FAQ Number 07-0039

FAQ Title Lessons Learned – NEI 04-02 B-2 Table

Plant: Harris

Date: September 9, 2008

**Figure XX – Summary of Nuclear Safety Methodology Review Process**

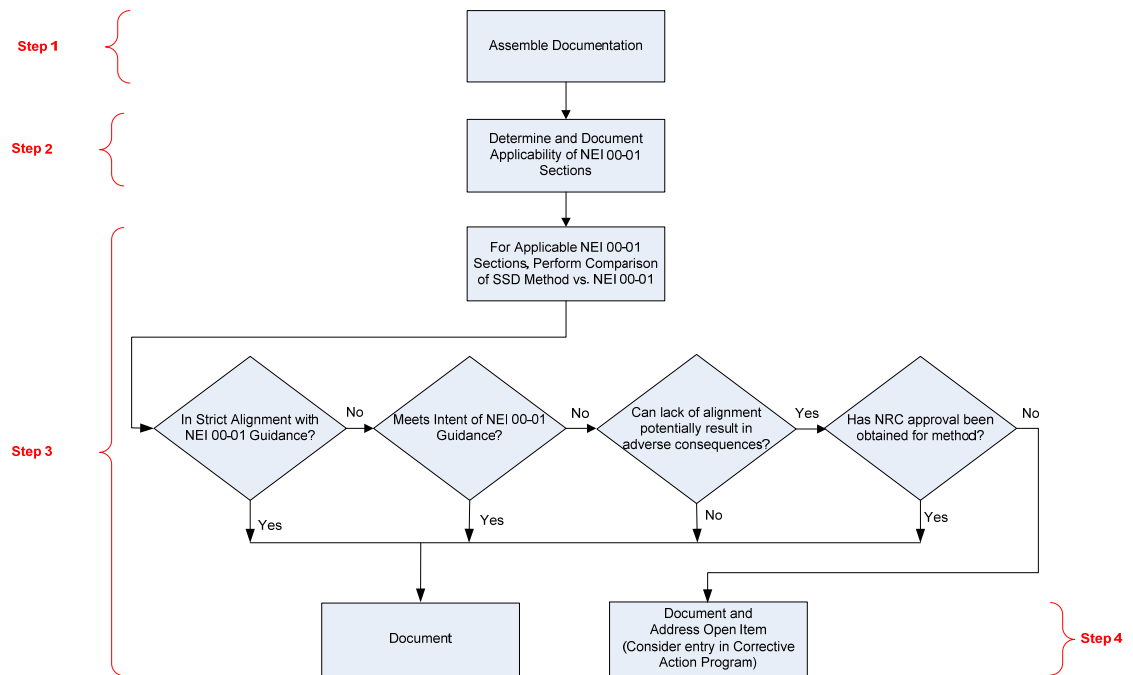
The suggested methodology for transition of the Nuclear Safety Performance Criteria is as follows:

Section 2.4.2 of NFPA 805 establishes the methodology for conducting a safety capability assessment for determining achievement of the nuclear safety criteria in NFPA 805 Chapter 1. To a large extent, the activities to be undertaken to implement this methodology have already been completed for the purposes of determining compliance with the existing requirements.

Tables B-2 and B-3 of this Appendix outline a recommended method to review the acceptability of a program for transition by examining the basic components of a nuclear safety capability assessment. These worksheets organize the transition of the ‘pre-transitional safe shutdown analysis’ to the ‘nuclear safety analysis’ as follows:

1. Nuclear Safety Capability System and Equipment Selection
2. Nuclear Safety Capability Circuit Analysis
3. Nuclear Safety Equipment and Cable Location
4. Fire Area Assessment
